**Village of Thiensville
Plan Commission
AGENDA**

**CHRIST ALONE 247 SOUTH MAIN STREET
CHRIST ALONE EVANGELICAL LUTHERAN CHURCH
PLAN COMMISSION REVIEW**

Re: Christ Alone Building Addition
Site Plans and Storm Water Review

BUILDING ADDITION SITE DEVELOPMENT PLANS VILLAGE OF THIENSVILLE, WISCONSIN

DESCRIPTION:
COVER SHEET

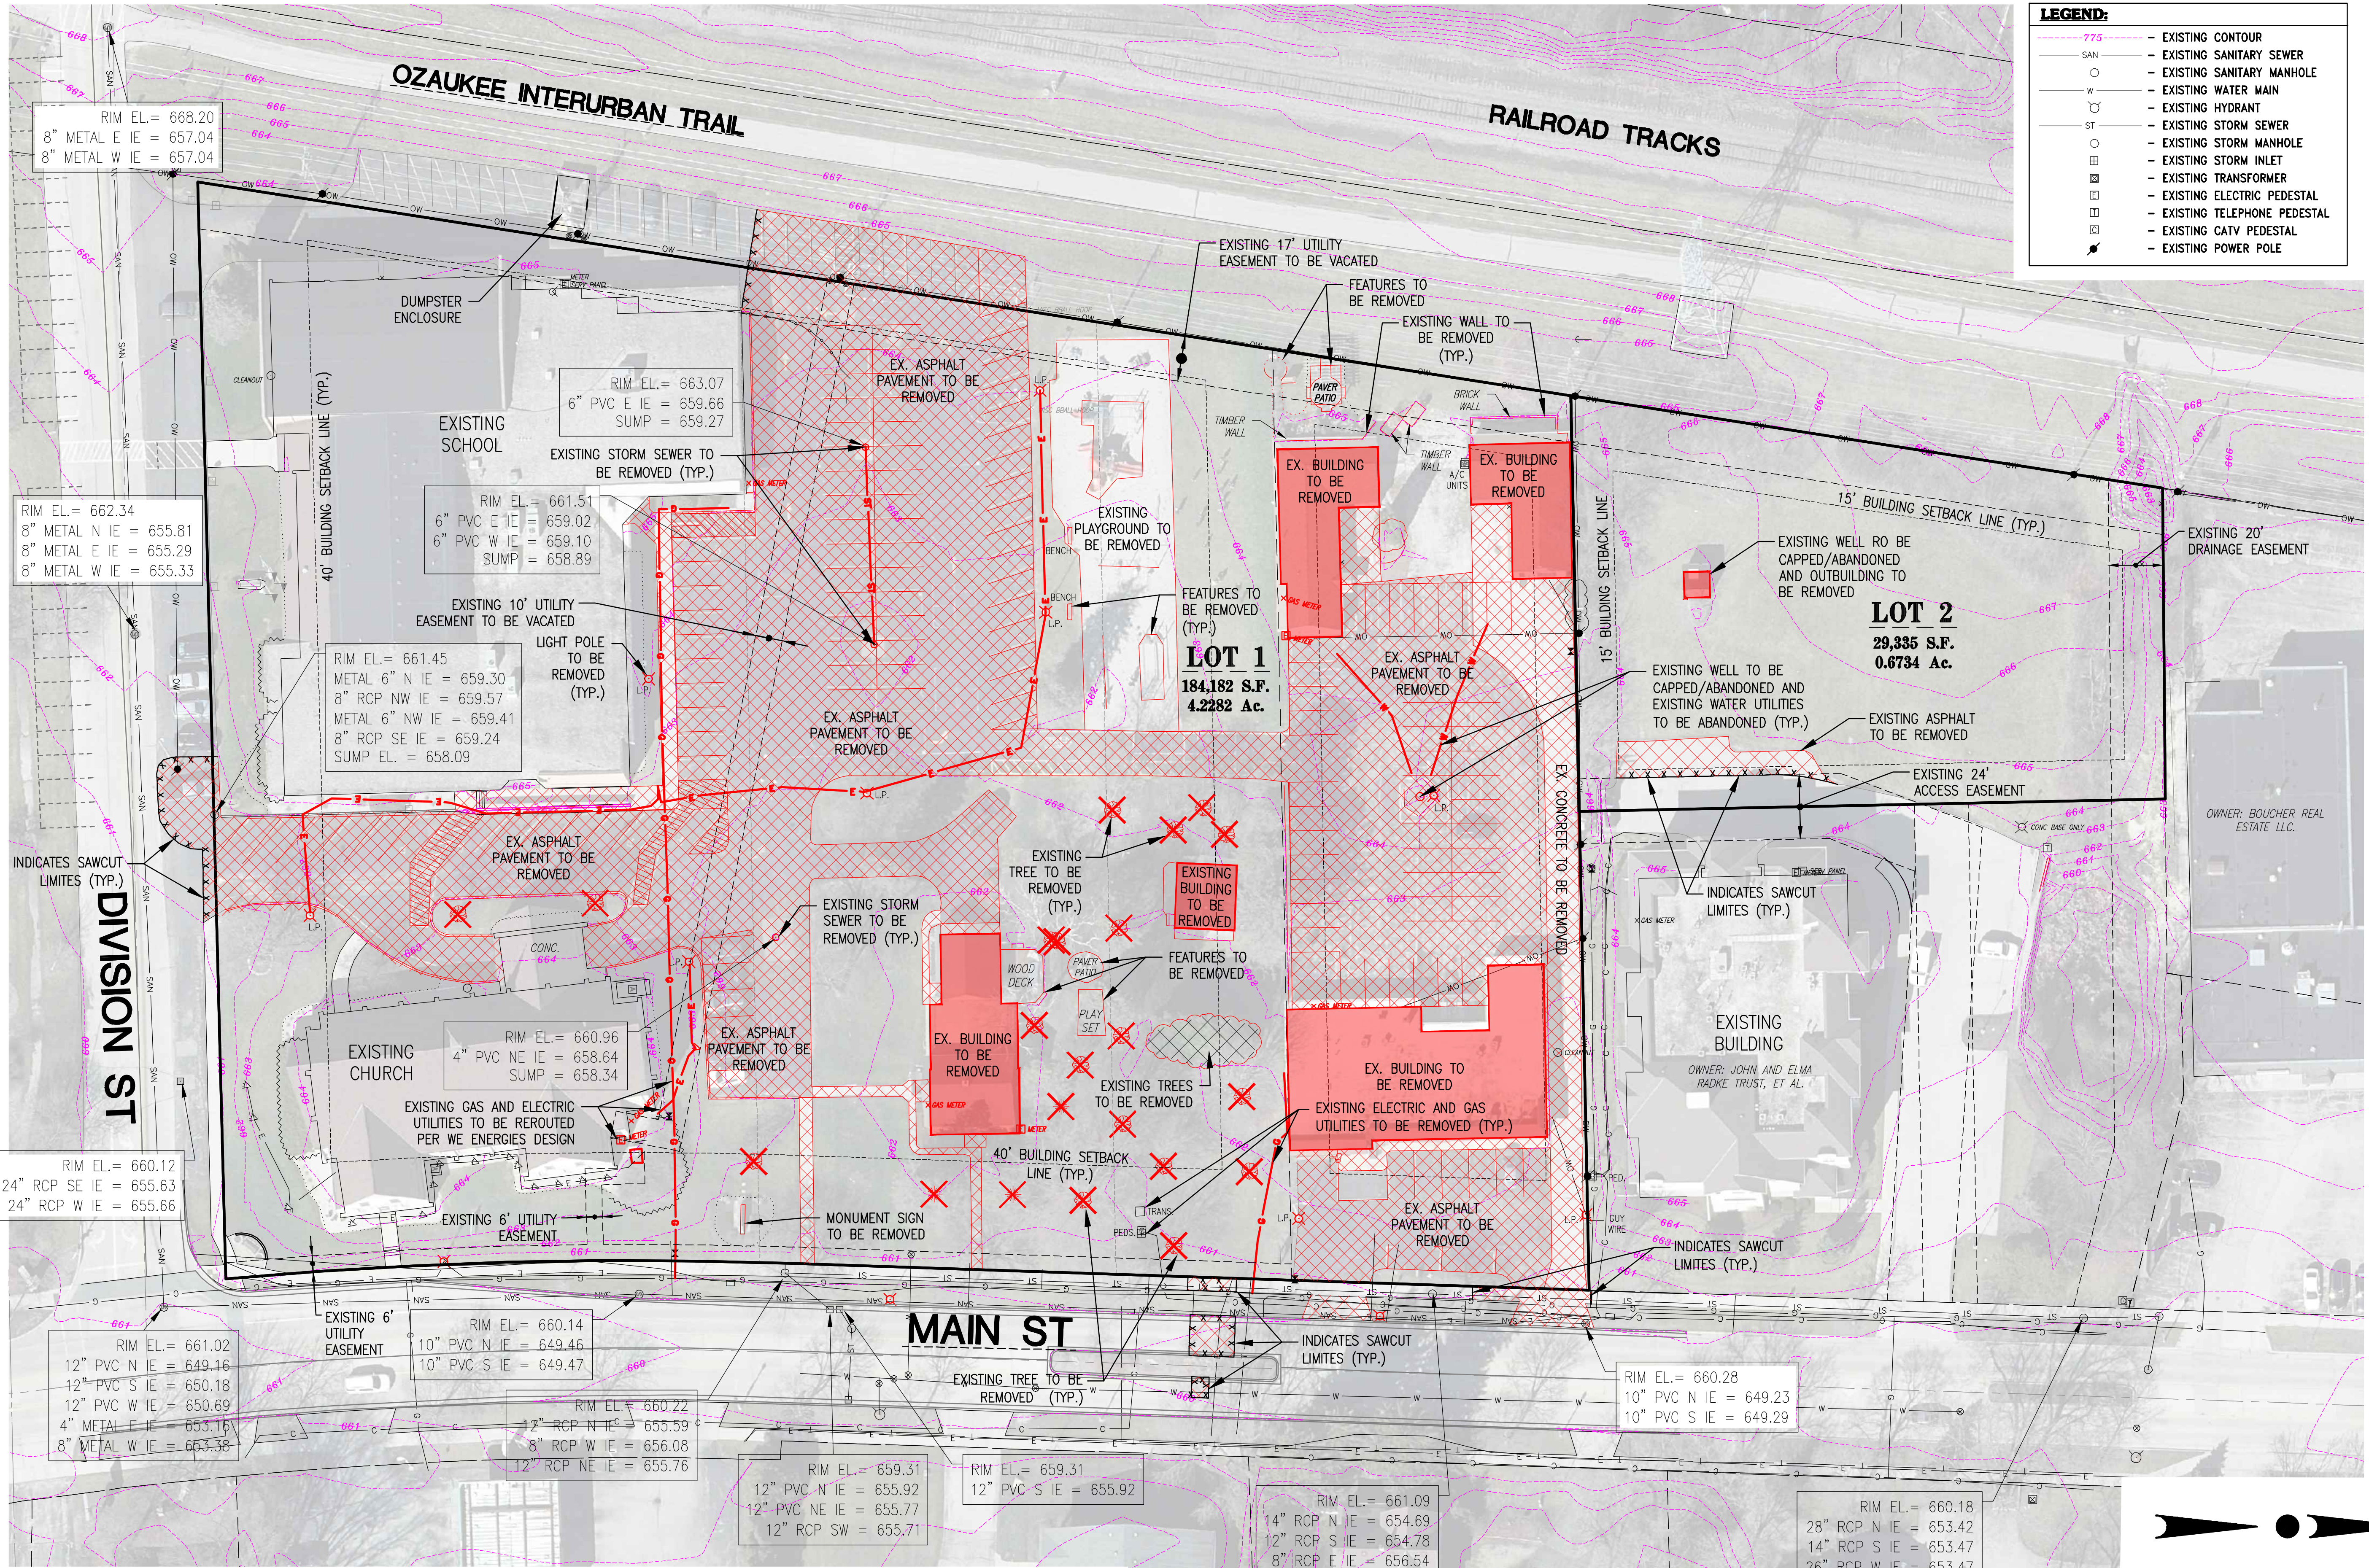
2. Plan Sheet T1 Cover Sheet:
 - a. Under General Notes no. 1, revise Village of Mequon reference to "City of Mequon Standard Specifications."
 - b. Under General Notes no. 12, revise Village of Thiensville reference to "City of Mequon Water Utility."

DESCRIPTION:
EXISTING SITE PLAN

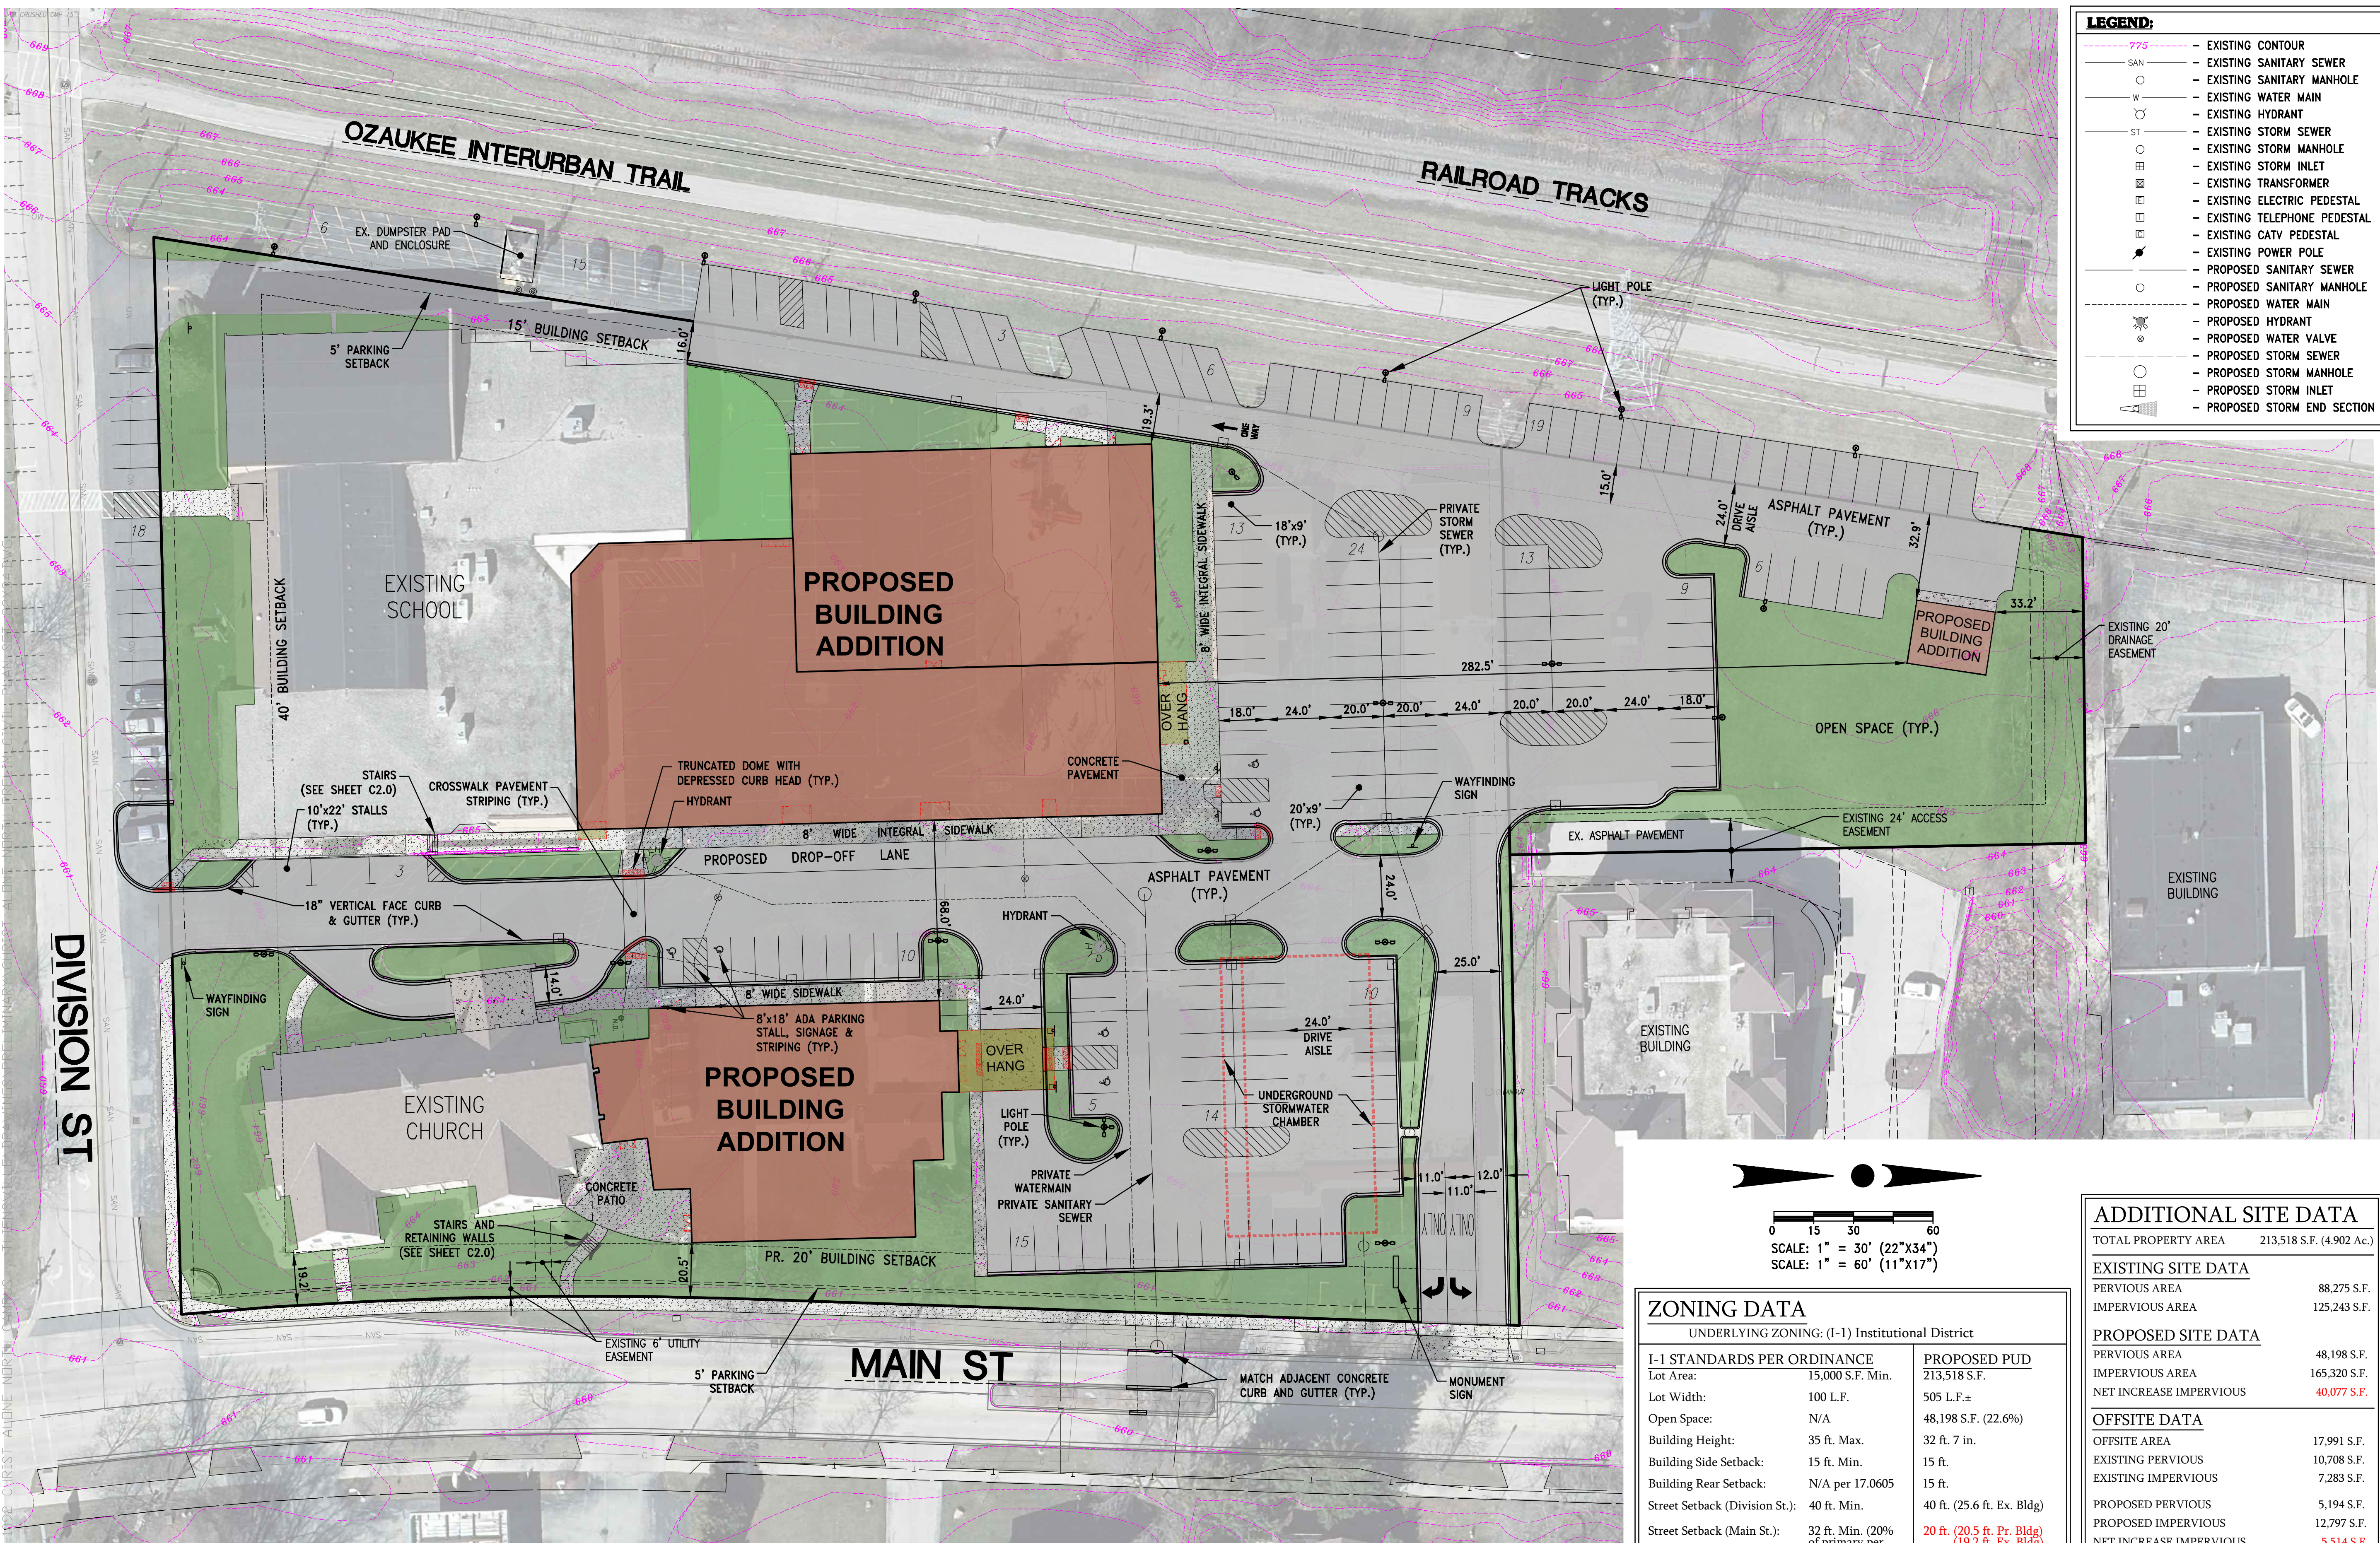
3. Plan Sheet C1.0 Existing Site Plan:
 - a. Show proper abandonment of existing 6" water service on Main Street.
 - b. Show existing storm sewer on property (north of existing church building) to be removed and add note to cap/bulkhead 8" sewer opening in existing storm manhole.
